Z-33
(2011)

PETITION NO.: Z-33

PROPOSED USE: Light Auto Repair

ZONING COMMENTS:

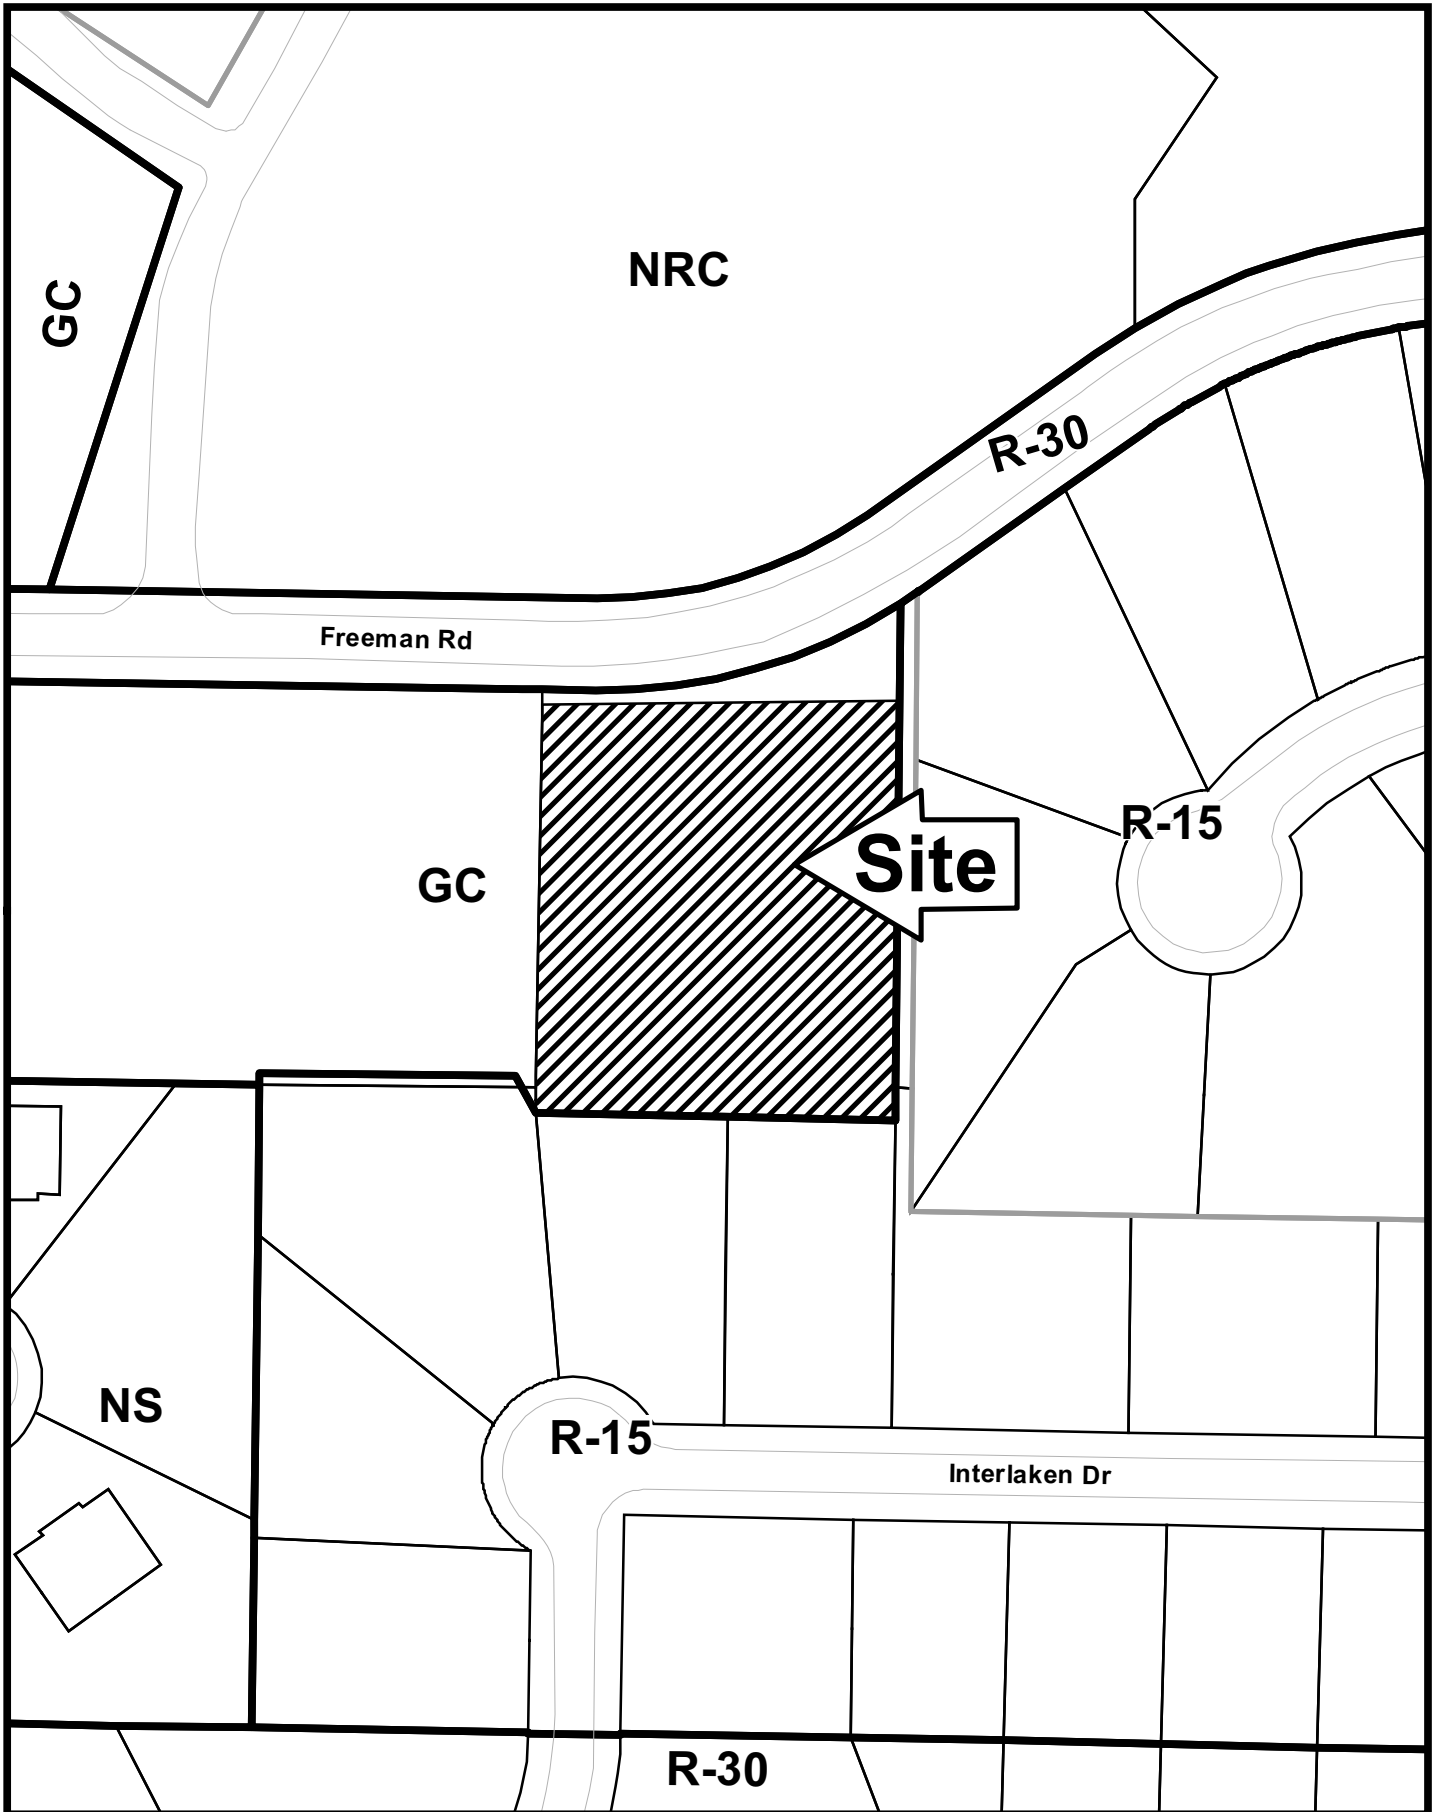
DRAINAGE COMMENTS

- FEMA Designated 100 year Floodplain Flood.
- Flood Damage Prevention Ordinance DESIGNATED FLOOD HAZARD.
- Project subject to the Cobb County Flood Damage Prevention Ordinance Requirements.
- Dam Breach zone from (upstream) (onsite) lake - need to keep residential buildings out of hazard.

- Potential or Known drainage problems exist for developments downstream from this site.
- Stormwater discharges must be controlled not to exceed the capacity available in the downstream storm drainage system.

- Stormwater discharges through an established residential neighborhood downstream.
- Project engineer must evaluate the impact of increased volume of runoff generated by the proposed project on downstream receiving system. There is limited capacity in the pipe system leading from the site through the existing residential lots to the downstream Byron's Pond S/D lake/detention facility.

- Provide comprehensive hydrology/stormwater controls to include development of out parcels.
- Submit all proposed site improvements to Plan Review.
- Any **spring activity** uncovered must be addressed by a qualified geotechnical engineer (PE).
- Structural fill _____ must be placed under the direction of a qualified registered Georgia geotechnical engineer (PE).
- Existing facility.
- Project must comply with the Water Quality requirements of the CWA-NPDES-NPS Permit and County Water Quality Ordinance.
- Water Quality/Quantity contributions of the existing lake/pond on site must be continued as baseline conditions into proposed project.
- Calculate and provide % impervious of project site.
- Revisit design; reduce pavement area to reduce runoff and pollution.

- No Stormwater controls shown _____
- Copy of survey is not current - Additional comments may be forthcoming when current site conditions are exposed.
- No site improvements showing on exhibit.
